# EMERGENCY ALERT SERVICE BULLETIN

### TIME LIMITS - MAINTENANCE CHECKS - Tail Rotor Hub

HELICOPTER CONCERNED	NUMBER	Version(s)	
		Civil	Military
EC120	05A020	B

Revision No.	Date of issue
Revision 0	2019-10-29
Revision 1	2019-11-08
Revision 2	2021-02-08

Figure 1

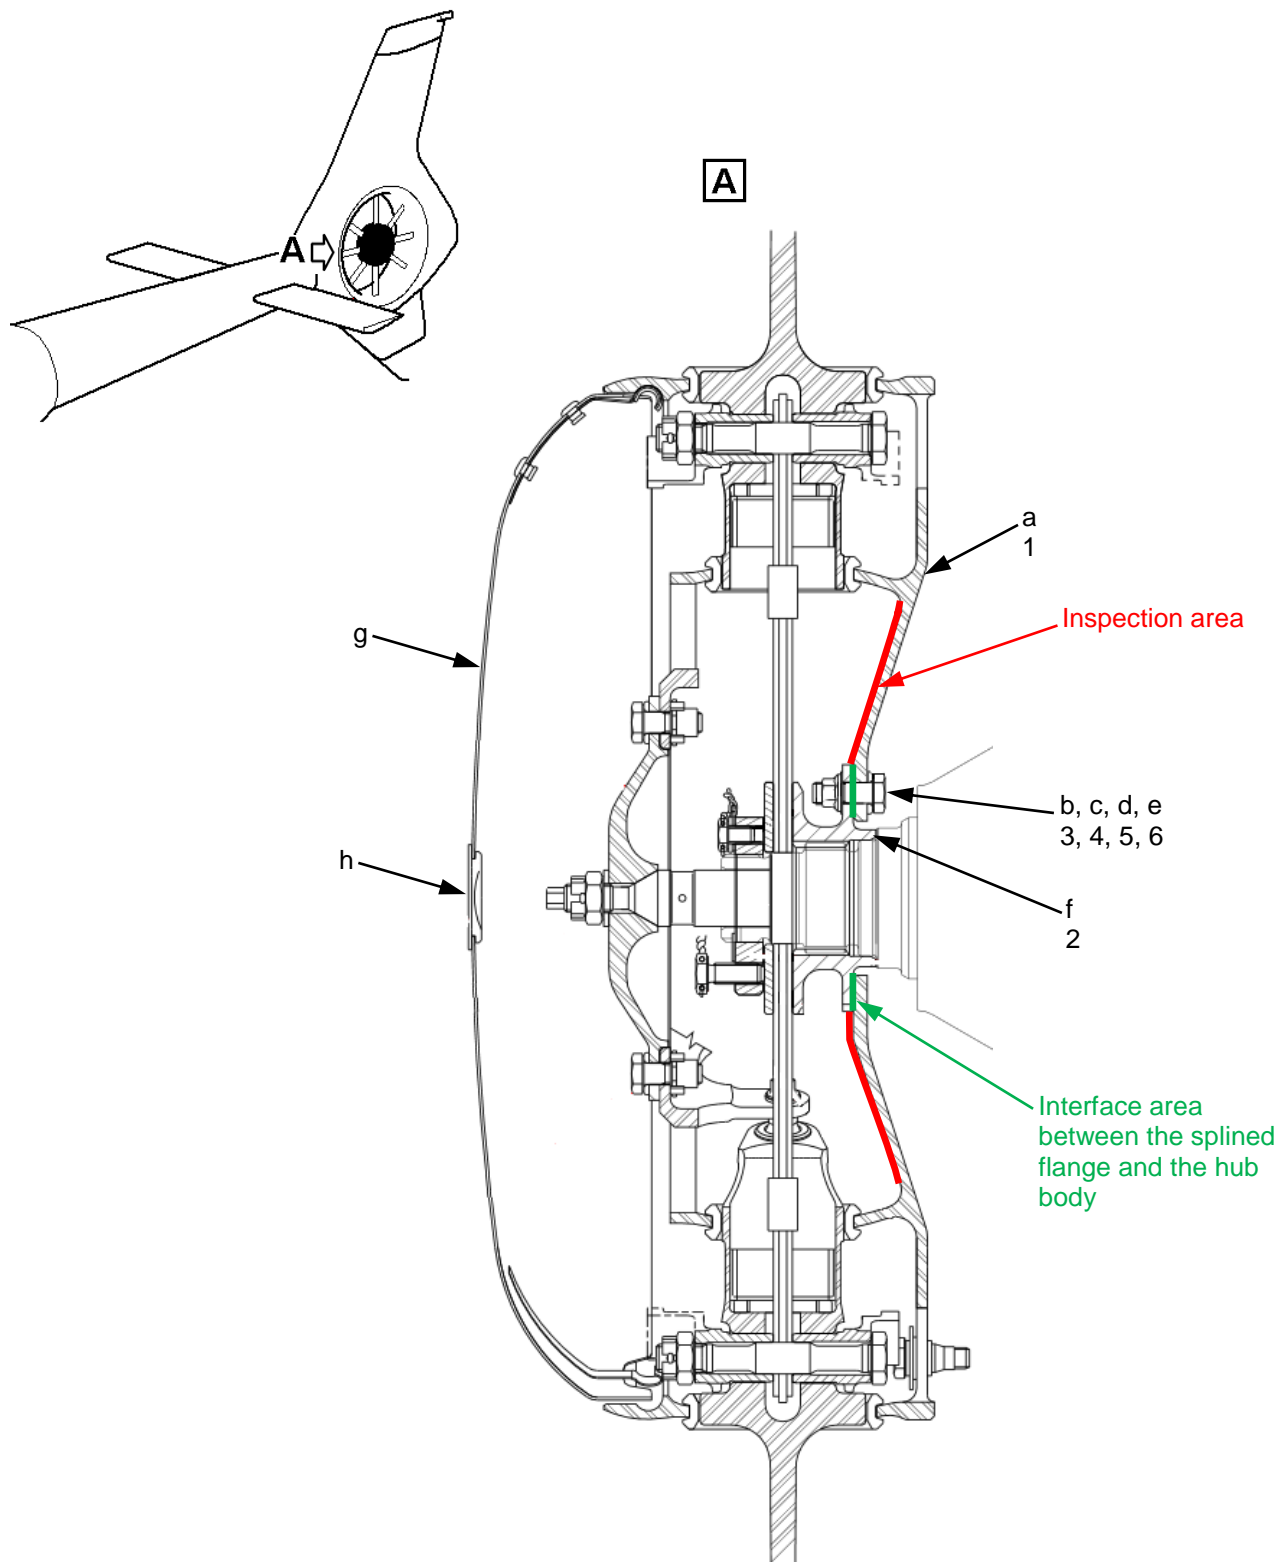
- performing a check for cracks on the tail rotor hub body, in the zones defined in [Figure 1](#),
- replacing the attachment bolts, washers and nuts of the tail rotor hub body,
- performing a check of the interface between the splined flange and the tail rotor hub body.

- Perform a visual inspection of the hub body (a), (Figure 1).
  - . Using a light source and, if necessary, a mirror (zz) (e.g. dentist's mirror), make sure that there are no cracks in the hub body, in the inspection area defined as per [Figure 1](#).
- Turn the tail rotor by hand to check the entire inspection area defined as per Figure 1.
- Interpret the results as per [paragraph 1.E.2](#).

- Remove and discard the hub body (a), ([Figure 1](#)) as per Task 64-21-00, 4-3 (AMM).
- Discard the bolts (b), the washers (c) and (d) and the nuts (e).
- Install the hub body (1) as per Task 64-21-00, 4-4 (AMM) with bolts (3), washers (4) and (5) and nuts (6).

- Remove the splined flange (f) ([Figure 1](#)) as per Task 64-21-00, 4-3 (AMM).
- Install the splined flange (2) as per Task 64-21-00, 4-4 (AMM).
